Project: WBS 42833.1.1 (B-5231)
 Bridge #162 on SR 1121 over Price Creek
 Yancey County

Subject: MINUTES OF MEETING

PURPOSE/DESCRIPTION:		Pre-Bid Meeting
DATE & TIME:		Wednesday, January 6, 2010 10:00 am
LOCATION:		NCDOT Bridge Management Unit Small Conference Room Raleigh, North Carolina
ATTENDEES		
Name	Representing	Telephone Number
	See Meeting Roster	
Jim Mondolfi	Ko/Florence & Hutcheson, Inc.	919-851-6066

STANDARD PRESTRESSED CORED SLAB
 60' SPAN
 27' CLEAR ROADWAY - 60° SKEW

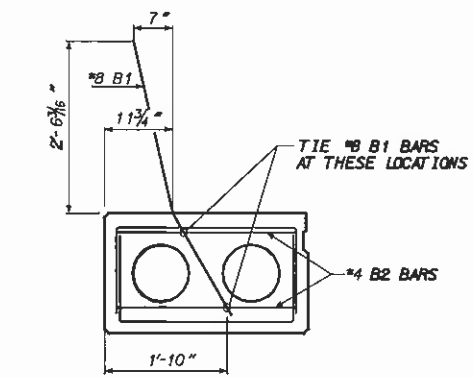
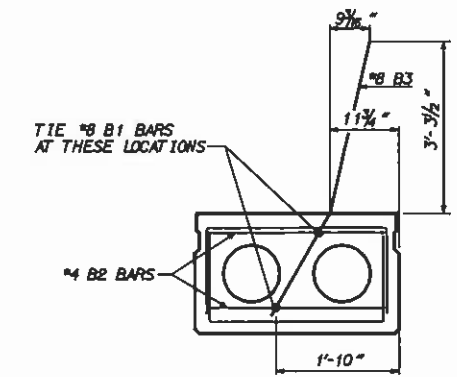
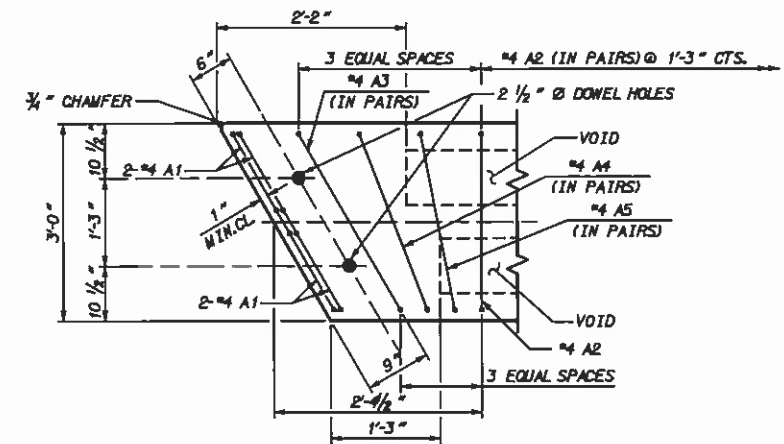
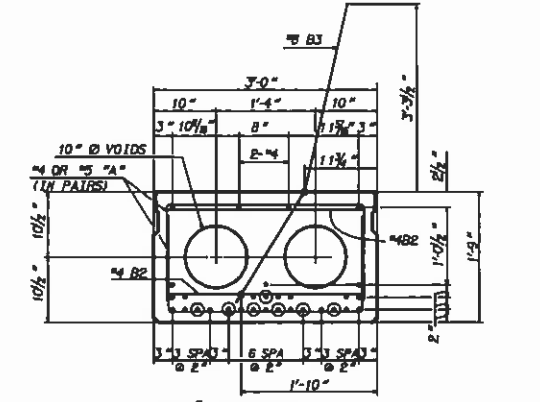
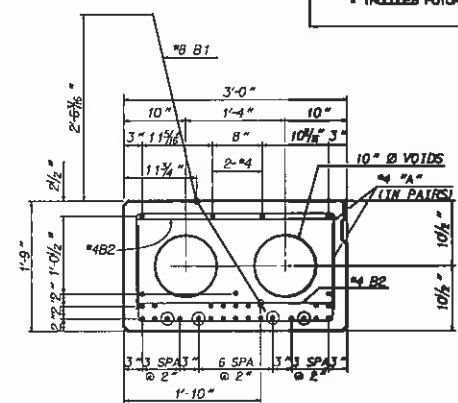
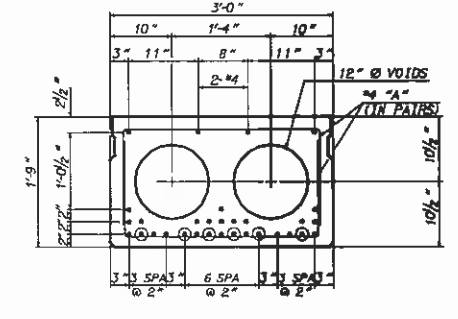
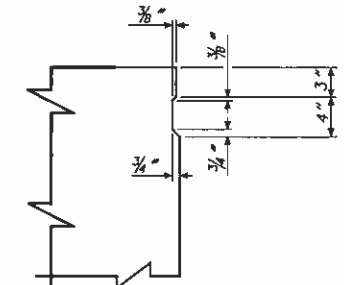
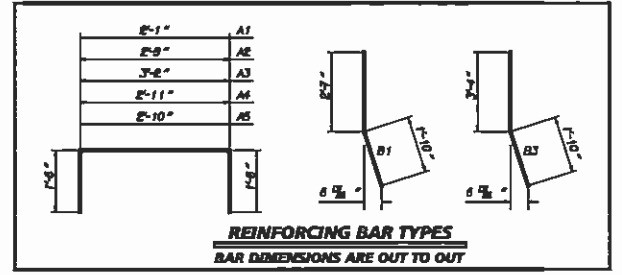
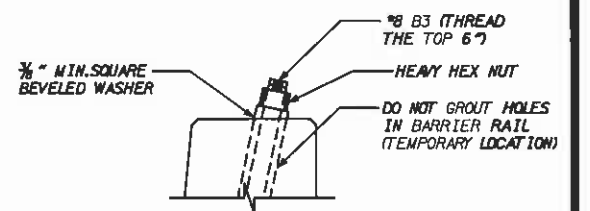
- 1) Revised Drawing 3 of 31 indicating cored slab details is attached.
- 2) Revised Drawings 4, 5, 6, 7, 8, 9, 13 & 13A was distributed to all attendees at the meeting. A complete set of drawings with revisions will be resubmitted to the BMU.
- 3) Page 5 in the Bid Proposal Document should read "Bids received after 2:00 pm, Tuesday, January 26, 2010 will not be accepted".
- 4) The existing bridge components will be removed and disposed of by the Contractor.

STANDARD PRECAST CONCRETE
BARRIER RAIL SECTIONS
60' SPAN
27' CLEAR ROADWAY - 60° SKEW

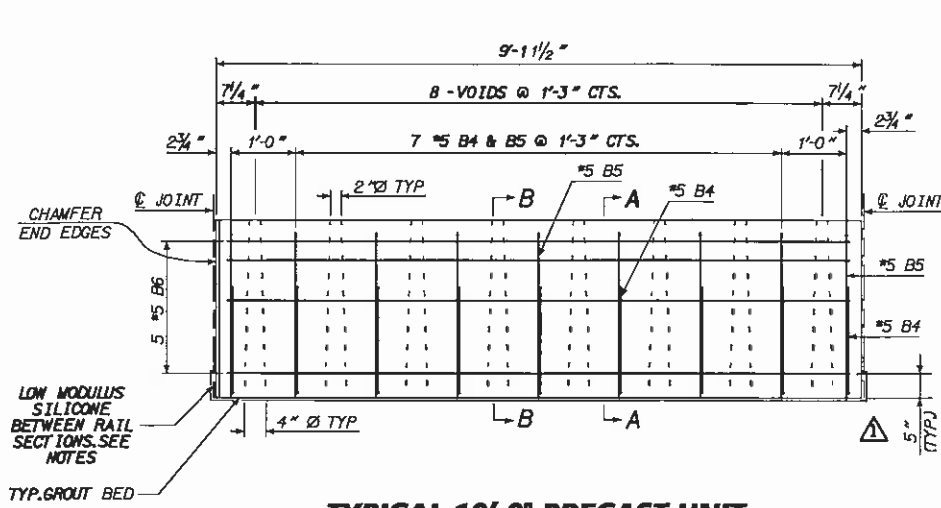
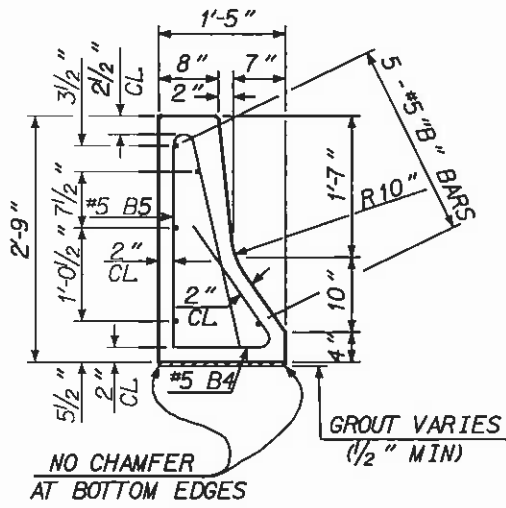
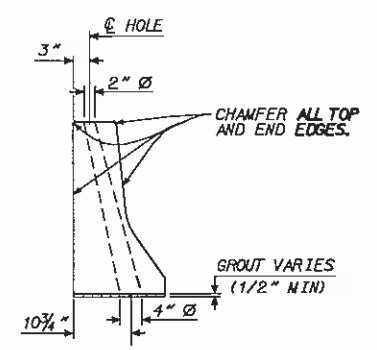
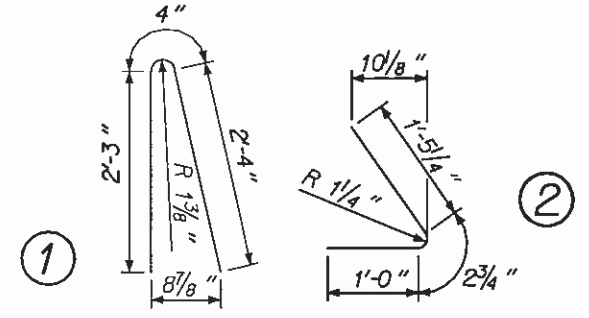
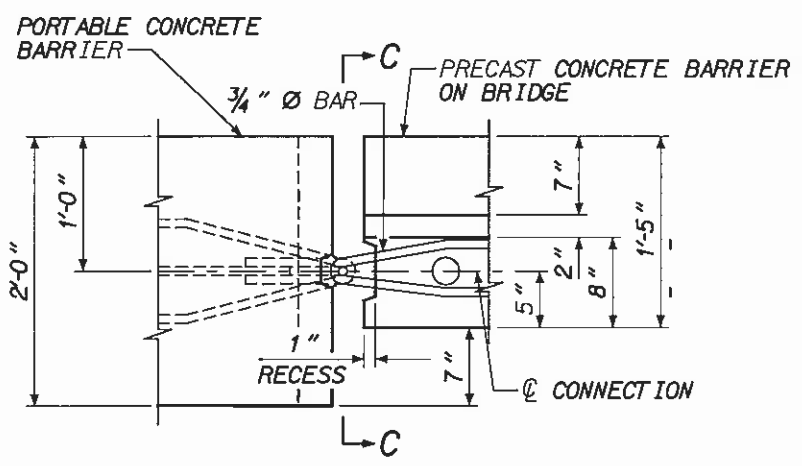
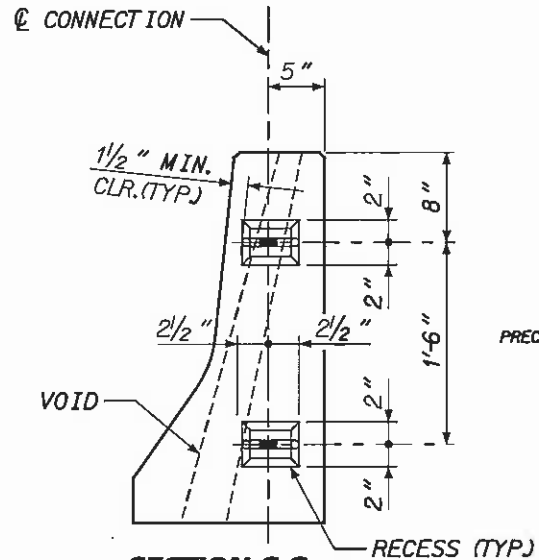
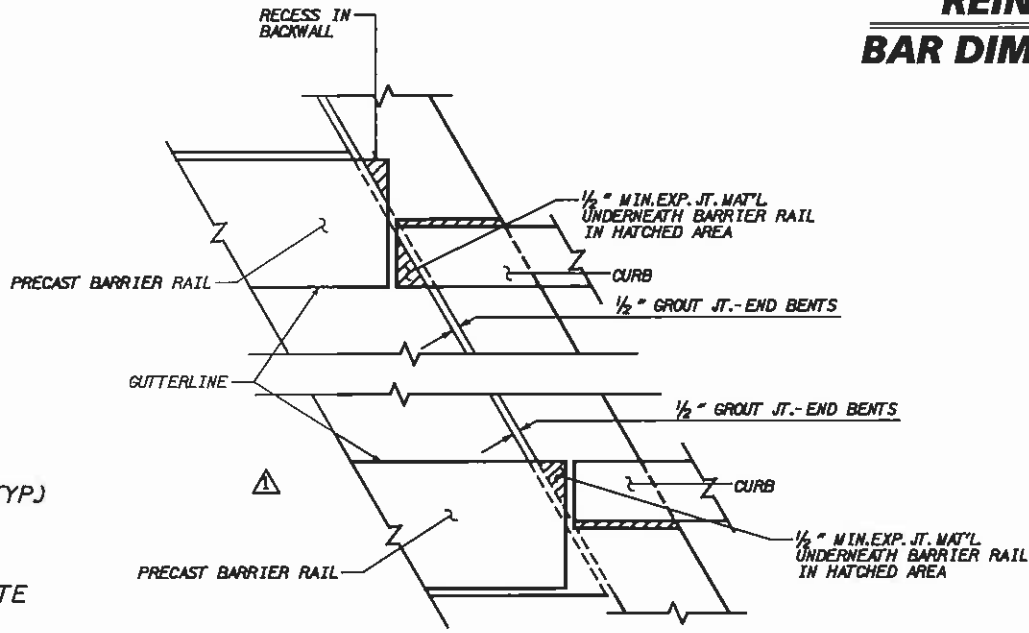
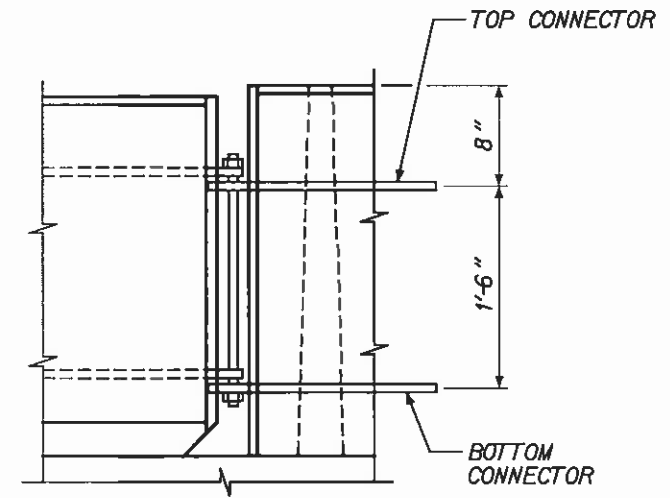
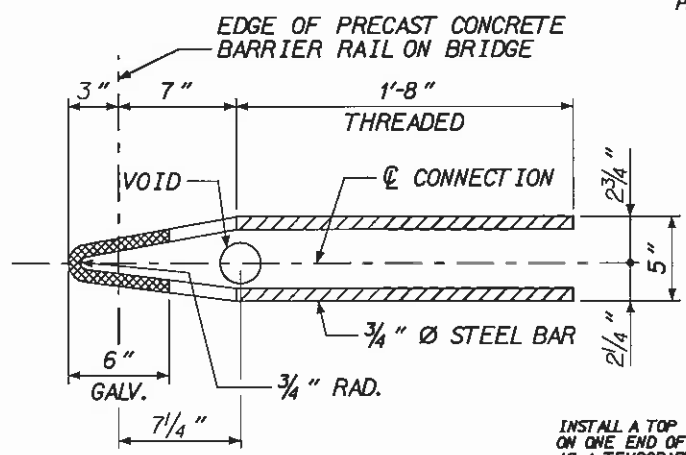
ADDED #5 INCH DIMENSION
REVISED NOTES
REVISED PLAN OF BARRIER RAIL DETAIL

STATE OF NORTH CAROLINA
DEPARTMENT OF TRANSPORTATION
RALEIGH
SUPERSTRUCTURE
GUARDRAIL ANCHORAGE
DETAILS

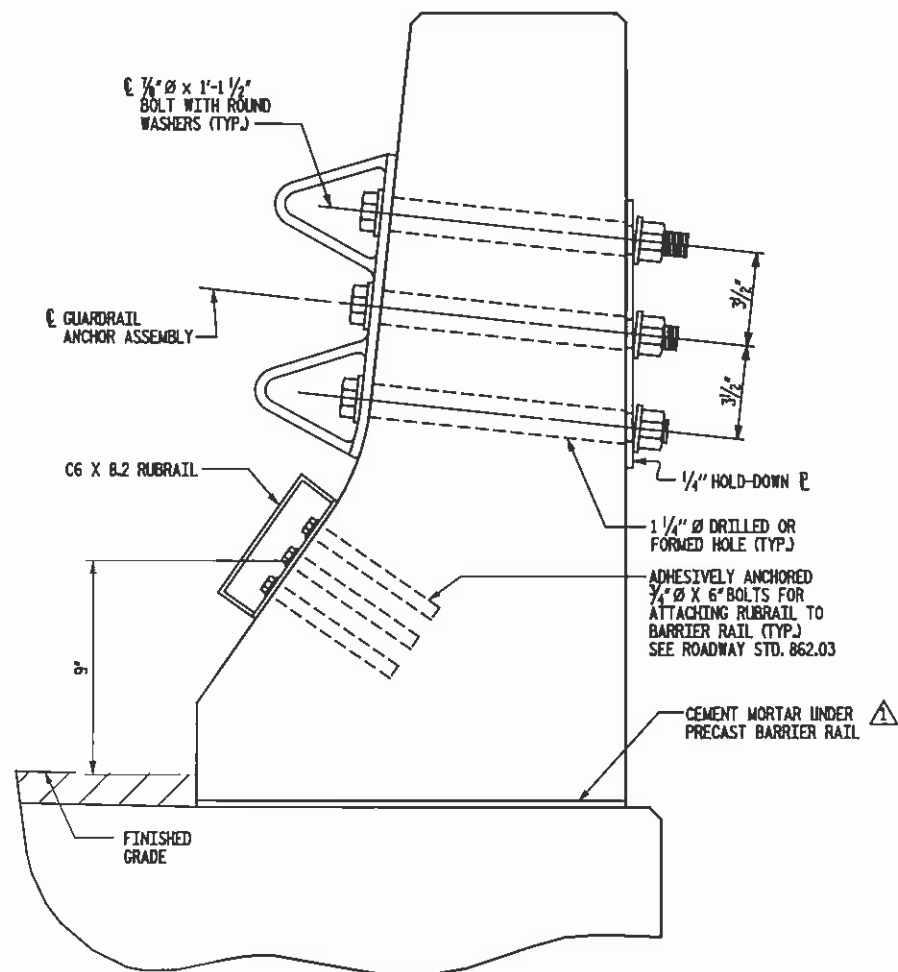
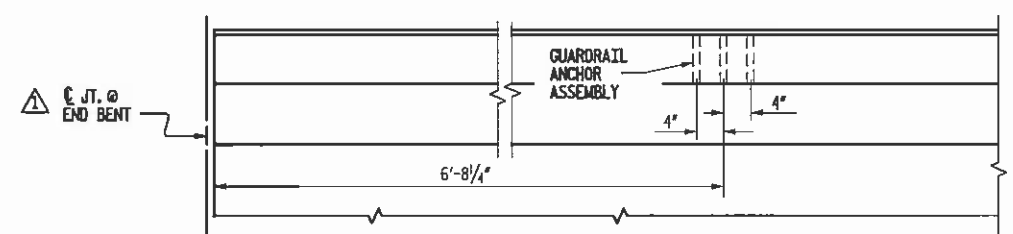
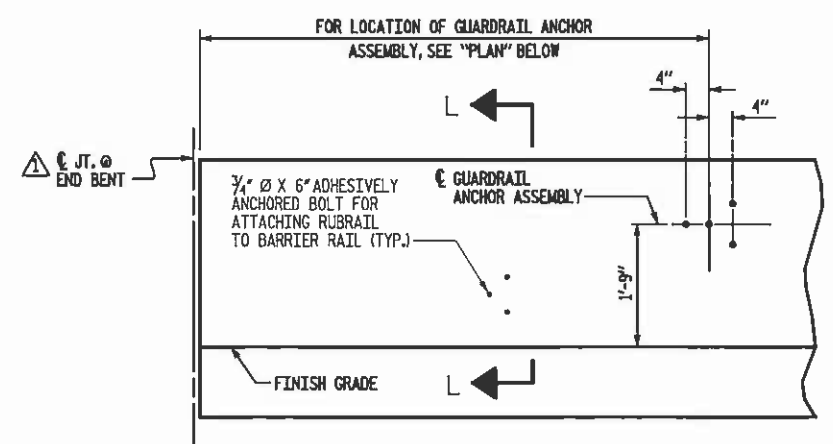
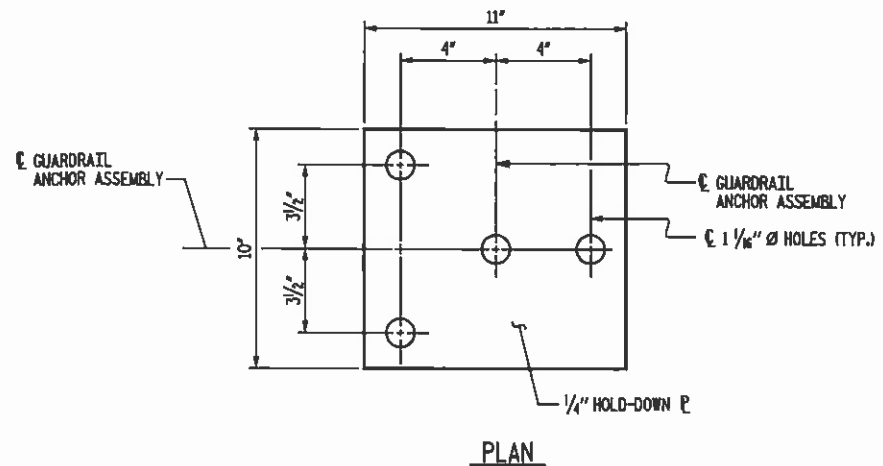
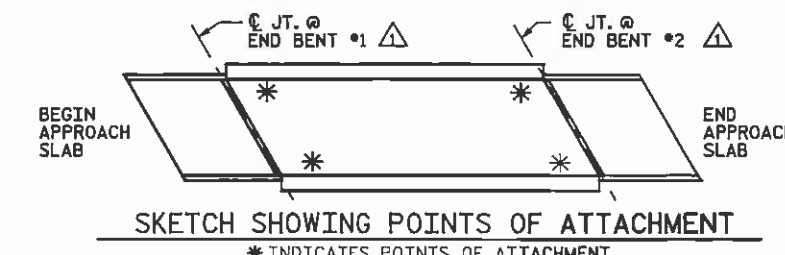
- △ REVISED NOTE.
- REVISED DESCRIPTION CALLOUT.
- ADDED MORTAR NOTE.

STATE OF NORTH CAROLINA
DEPARTMENT OF TRANSPORTATION
RALPHIGH
CAST - IN - PLACE
END BENT NO. 2
60' SPAN WITH APPROACH SLAB
27' CLEAR ROADWAY - 60° SKEW

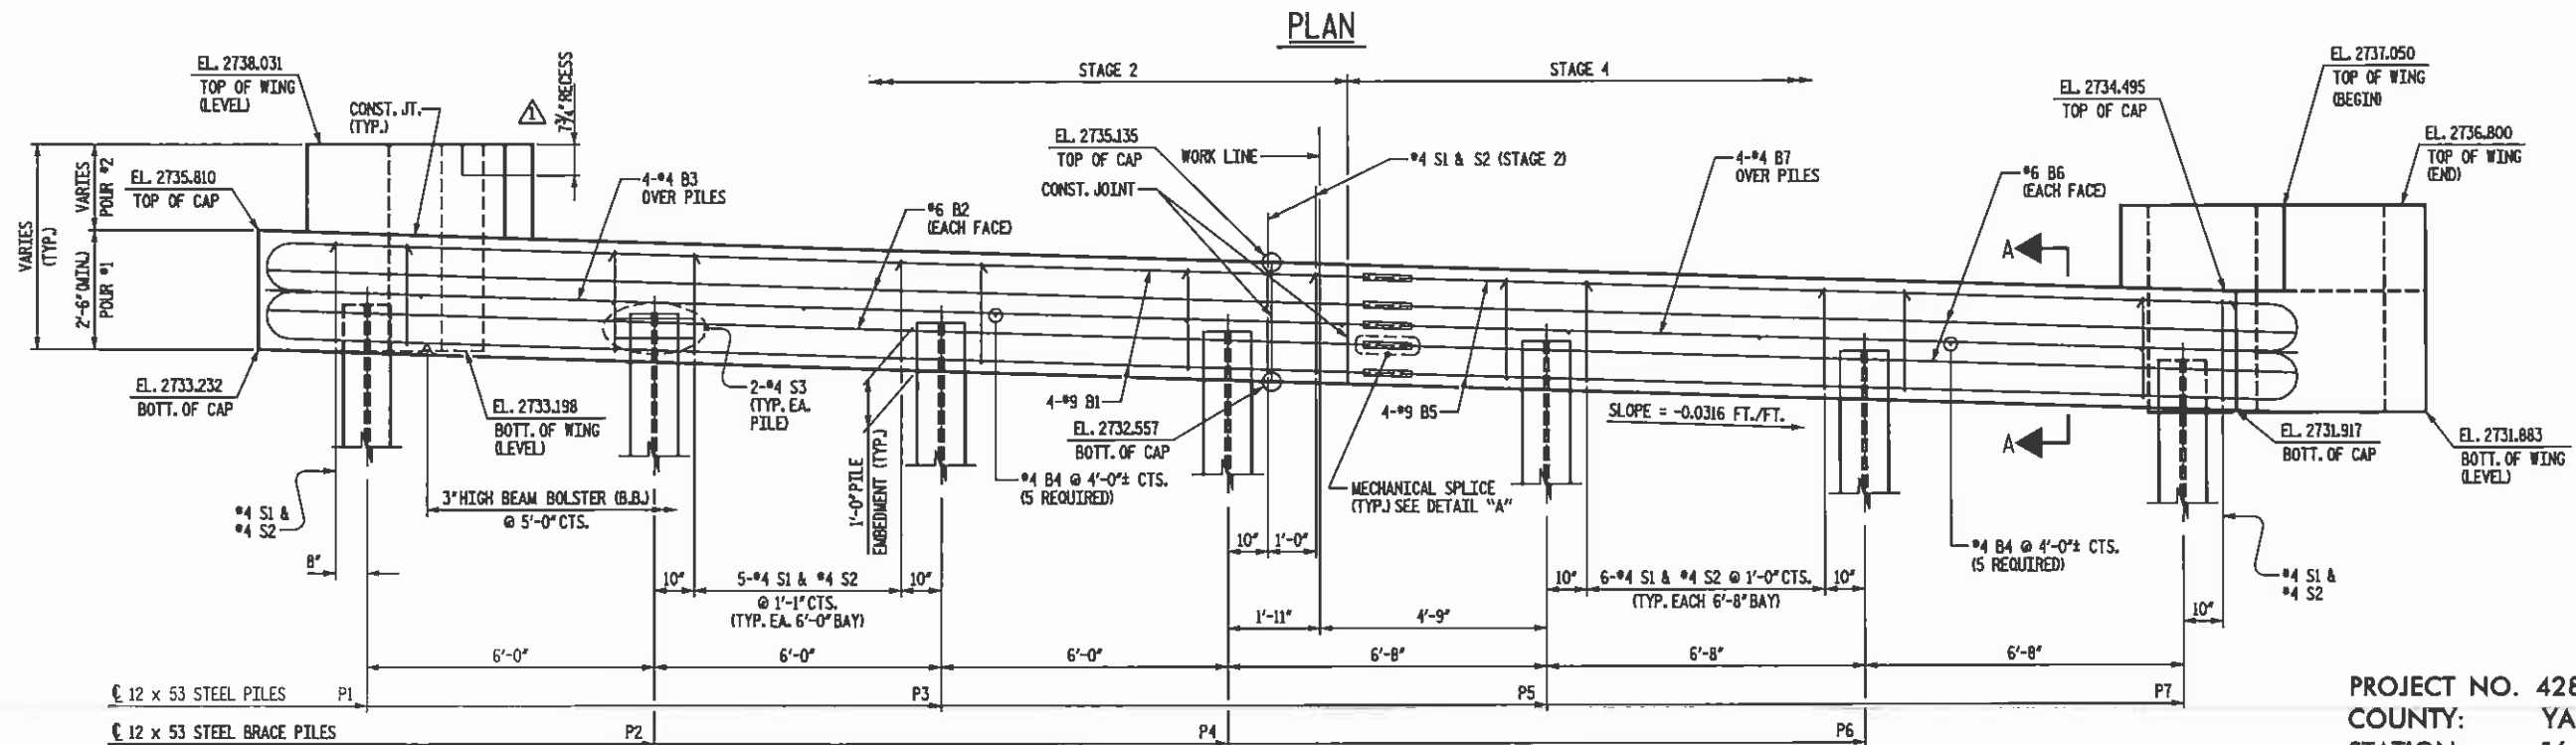
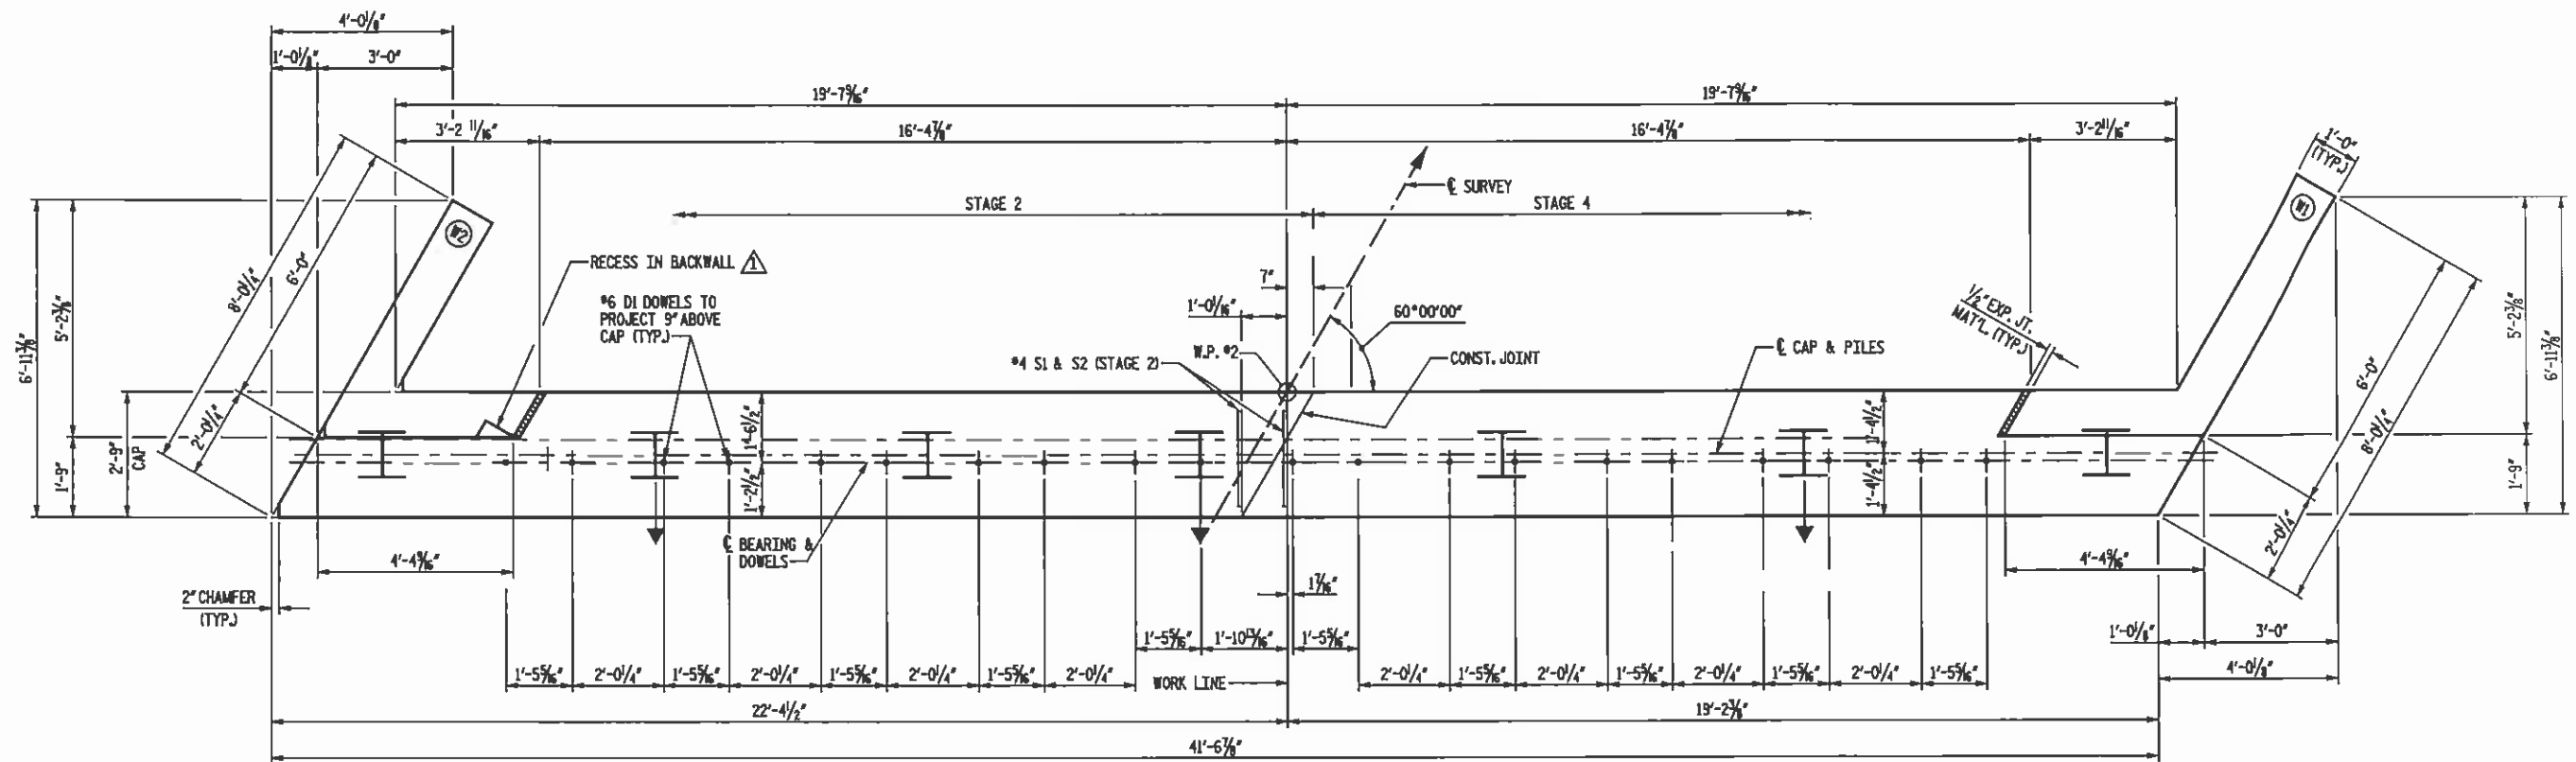
▲ ADDED RECESS IN BACKWALL
REMOVED SECOND NOTE

DETAIL OF RECESS
IN TOP OF BACKWALL
AT WING W2

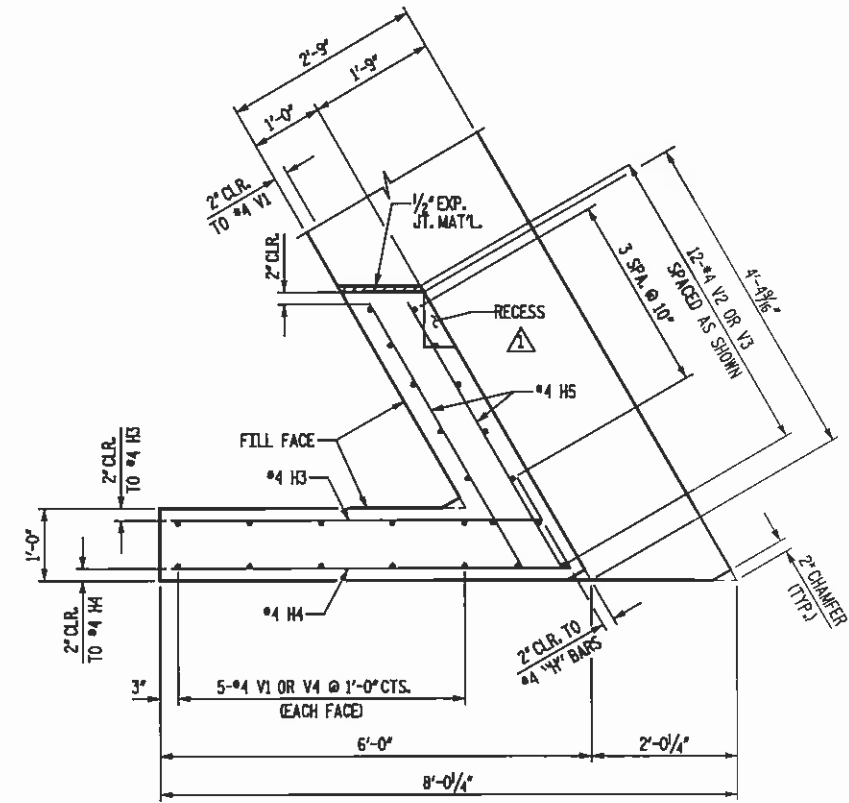
ADDED RECESS DETAIL AND NOTE

NOTE:
SHIFT, FIELD BEND OR CUT REINFORCING STEEL AS NECESSARY
TO CLEAR RECESS IN TOP OF BACKWALL.
